Product hierarchy no. *			Part no.	SBU	Type / Description	Customer part no.
SBU	PG	Type				
01	002	002	0000000508	See list below	Fuseholder (complete and socket)	FIN
01	002	063	0000000593	See list below	Fuseholder (carrier)	FIN

Product Change Notification						FIN plastic material change	
owner	creation date	release date	released by	change order no	rev	page	D10-007-251
zbindeja	2016-08-11	2016-10-07	nowakfr	2010727	A	1 of 2

Old product appearance		New product appearance

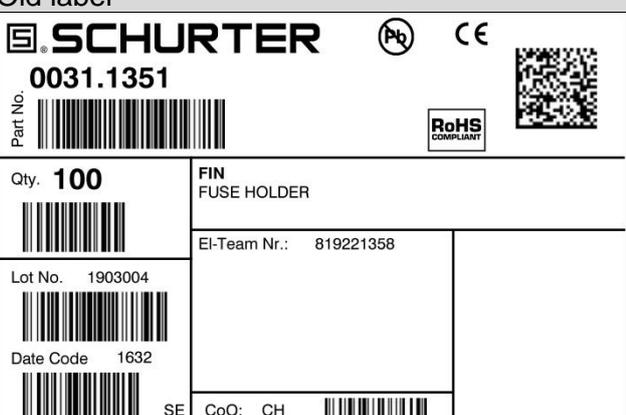
- Change of material
- Modified marks
- Modified label

- Product improvement to fulfil the enhanced glow wire requirements according to the updated standard IEC 60127-6 and the standard IEC 60335-1 for appliances in unattended use.
- Recertification by VDE

Form	Yes	Change of plastic material, modified marking on product
Fit	No	No change for dimension
Function	No	No change in function
Production Site	No	No change of manufacturing site
Product Label	Yes	VDE and cURus marks added Electrical ratings added Configuration code added
Packaging	No	No change in packaging
